Cherokee Nation Justice Center
Tahlequah, Oklahoma

CM Addendum #2

Addendum #1
Cherokee Nation of Oklahoma
Tahlequah Justice Center

June 24, 2026

EUP1.02

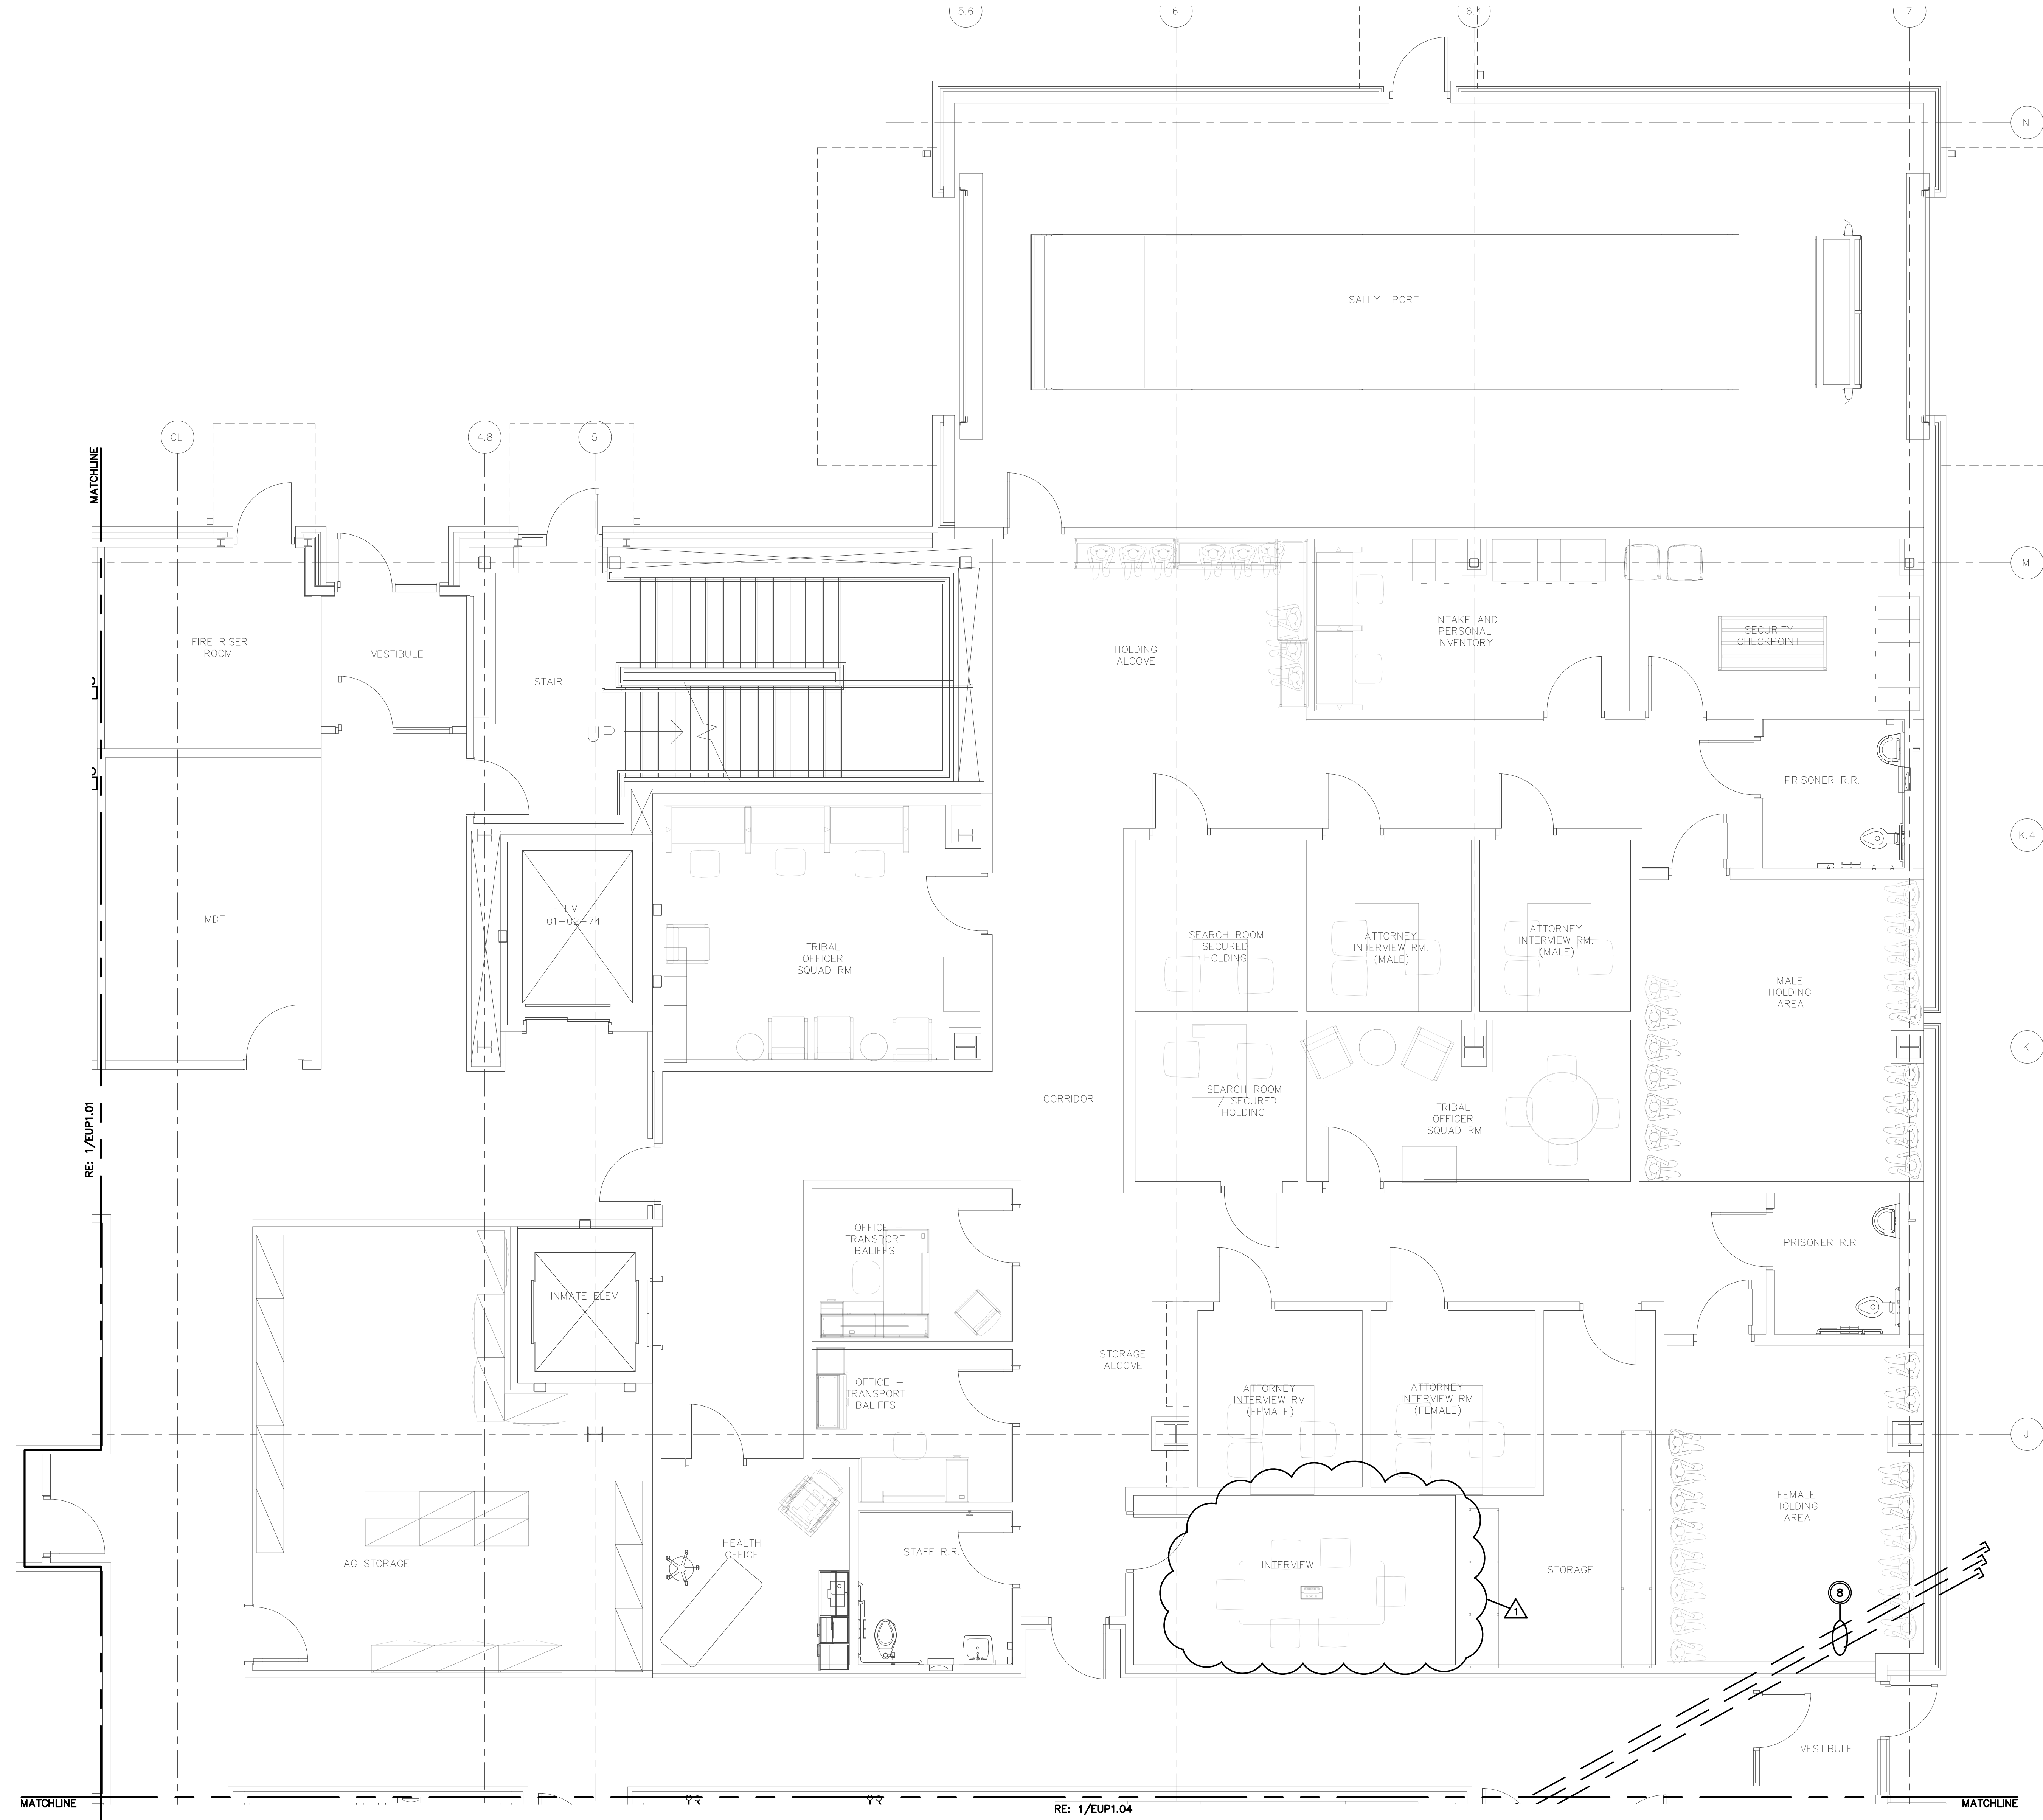
- 8) For **Trade Contract 26A – Electrical** – Reference document "22-08.33 ADDENDUM 01 BP02.1" Drawings EUP1.02 and EUP1.04 have been revised which includes the removal of specific floor boxes.

1. Reference Drawing EUP1.02 – Update power plan per architect's requests.
2. Reference Drawing EUP1.04 – Update power plan per architect's requests.
